SUBJECT: ISSUANCE OF AMENDMENT NO. 58 TO FACILITY OPERATING LICENSE NPF-9 AND  
AMENDMENT NO. 39 TO FACILITY OPERATING LICENSE NPF-17 - MCGUIRE  
NUCLEAR STATION, UNITS 1 AND 2

ATTACHMENT TO LICENSE AMENDMENT NO. 58

SITE BOUNDARY FOR  
 LIQUID EFFLUENTS  
 McGUIRE NUCLEAR STATION

FIGURE 5.1-4

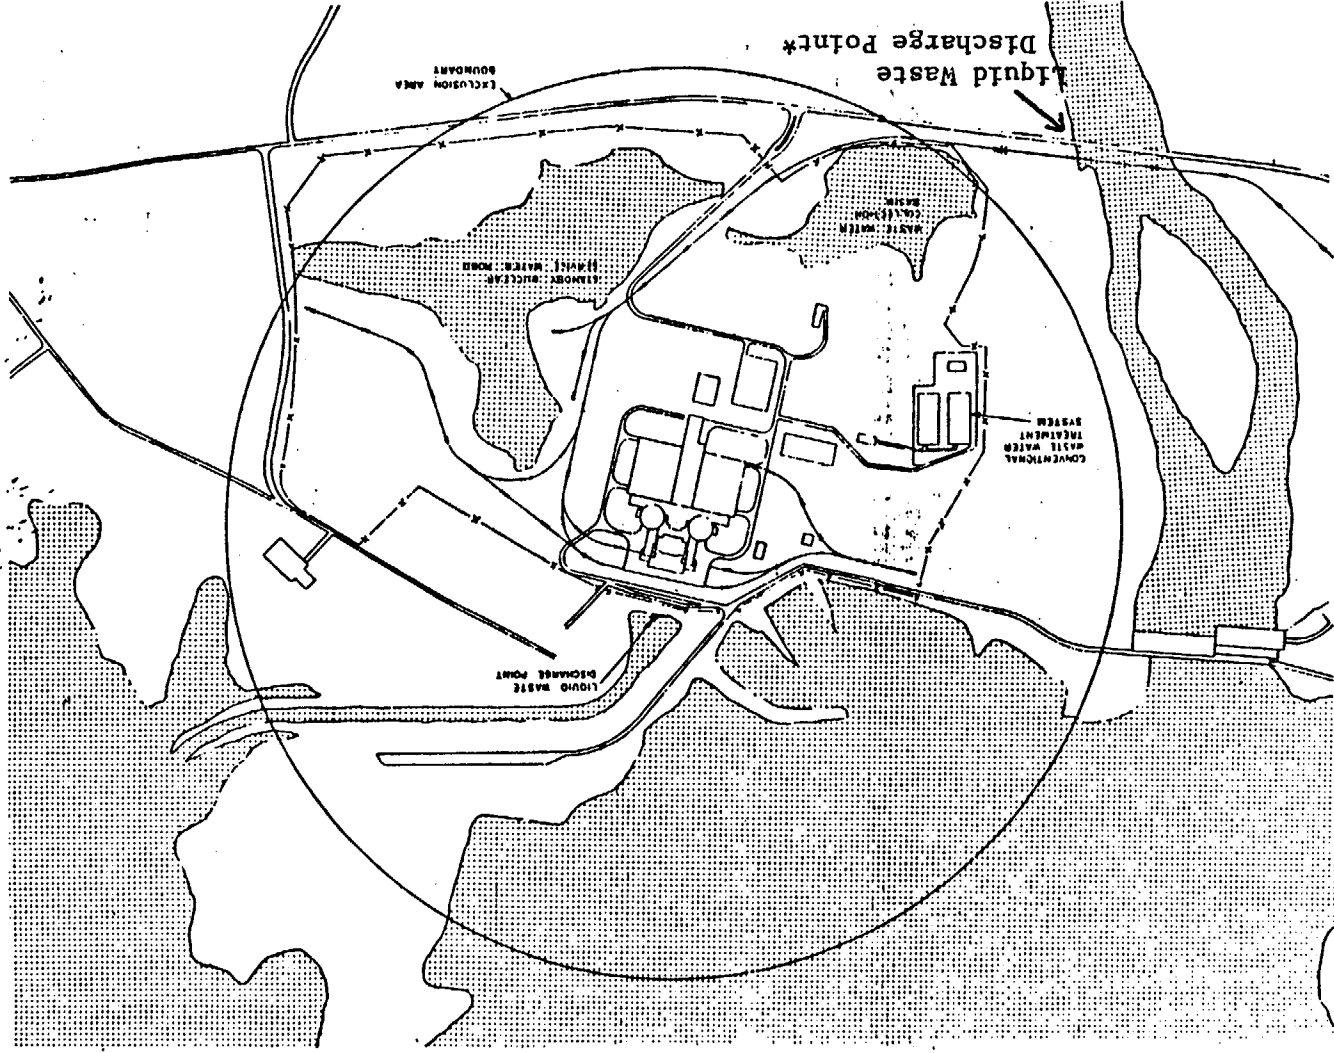
The amendments change Figure 5.1-4 of the Technical Specifications to permit a one-time discharge to the Catawba River of wastewater from the Conventional Wastewater Basin containing very low concentrations of tritium. The amendments are effective as of the dates of issuance.

\*This discharge point is authorized for a one-time discharge of water from the Conventional Wastewater Basin which contains trace amounts of tritium in addition to the normally processed effluents of the Waste Water Collection Basin, effective June 20, 1986.

These amendments authorize a one-time release of the existing contents of the Conventional (non-radioactive) Wastewater Basin, containing trace amounts of tritium, into the Catawba River. Technical Specification (TS) 3.11.1.1 and its referenced Figure 5.1-4, "Site Boundary for Liquid Effluents" define the authorized discharge point for radioactive material released in liquid effluents to unrestricted areas as being only to Lake Norman. The authorization is accomplished by the addition of a footnote to TS Figure 5.1-4 at the discharge point for the Conventional Wastewater Basin into the Catawba River, stating that this discharge point is authorized for a one-time discharge of water which contains trace amounts of tritium in addition to the normally processed effluents of the Waste Water Collection Basin, effective the date of Commission approval. The change does not affect any existing limits or procedures regarding the processing of conventional (i.e., non-radioactive) contaminants. These revisions to the technical specifications are made in response to the licensee's application for amendments dated May 20, 1986.

By letter dated May 20, 1986, the licensee noted that tritium, but no other radionuclide, had entered the Basin and had subsequently been diluted to a concentration of  $1.4 \times 10^{-5}$  microcuries per milliliter. The licensee proposed to discharge the 4 million gallons of water in the Basin, along with its tritium, to the river at a rate of 500 gpm over a duration of 133 hours. The Basin discharge would also be mixed by at least equal flow from the Standby Nuclear Service Water Pond, such that the tritium concentration at the river release point would be no more than  $7 \times 10^{-6}$  microcuries per milliliter. This

concentration is well within the limit of  $3 \times 10^{-3}$  microcuries per milliliter specified by 10 CFR 20.106 and associated Appendix B, Table II, for tritium concentrations in water released to an unrestricted area. The total amount of tritium to be released (about 0.25 curies) is small compared to the normal release of tritium from the plant (about 2.5 curies per day).
